Smith Ranch - Highland
Uranium Project
P. O. Box 1210
Glenrock, Wyoming USA 82637
Casper: 307-235-1628
Douglas: 307-358-6541
Fax: 307-358-4533

RE: Permit to Mine 603
A-Wellfield Long-Term Ground Water Monitor Plan

RE: Permit to Mine 603
A-Wellfield Revised Long-Term Ground Water Monitoring Plan

Figure 1

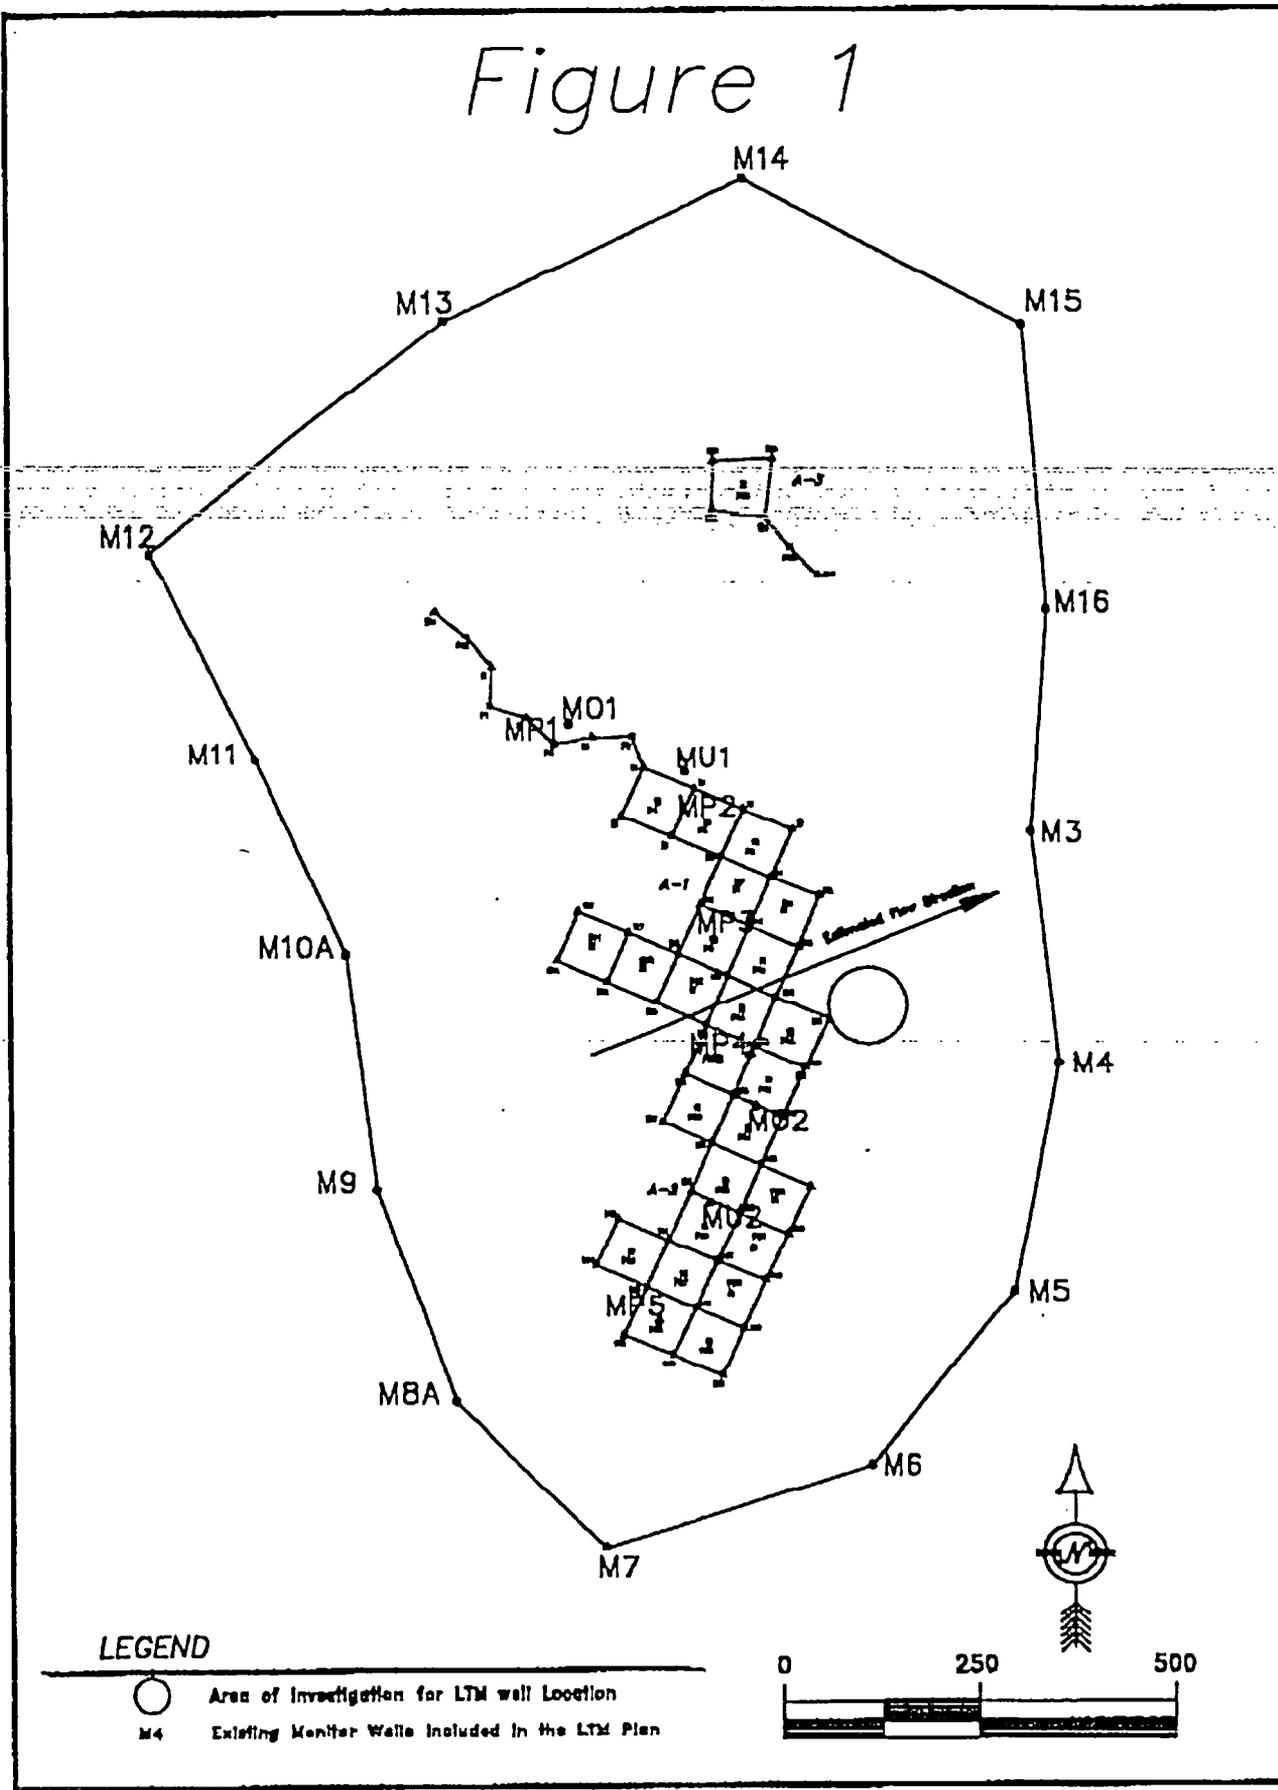
PRI accepts Mr. Ingle's first proposed modification to monitor Well MP-4 instead of Well MP-3.

In reference to Mr. Ingle's second proposed modification, PRI agrees to add an additional well to the LTM plan located on the oxidized side of the redox interface downgradient of the A-Wellfield. PRI believes that by adding an additional well closer to the wellfield edge, the duration of the LTM Plan may be decreased.

To determine the locations of the two new monitor wells, PRI will identify the extent of lateral flaring of mining solutions, which occurred during mining in the 20-Sand downgradient of the A-Wellfield. This is important since the restored ground water must be monitored as it moves through a geochemically reduced environment as opposed to the potentially slightly oxidized zone of flaring. Once this is accomplished, two LTM Wells will be located and completed in the appropriate zone to monitor the restored ground water as it migrates away from the wellfield. One of the new LTM Wells will be located within the zone of flaring, while the second LTM Well will be located downgradient in an area unaffected by mining solutions. These wells will be located northeast of a mining well (historic Production or Injection Well) that has been sampled for the constituents of concern. Figure 1 shows the area that is being considered for these LTM Wells.

PRI will utilize three wells already in use as monitoring wells to track changes in the 20-Sand ground water quality over time and distance (see Figure 1). Well MP-4 will track the changes within the wellfield as up gradient ground water flushes the restored wellfield area. Wells M-3 and M-4 will be used to detect any changes to the downgradient conditions that may potentially decrease the effectiveness of the natural attenuation process. Also, water level data, collected from all five wells will be used to determine the ground water gradient and flow rate in the 20-Sand.
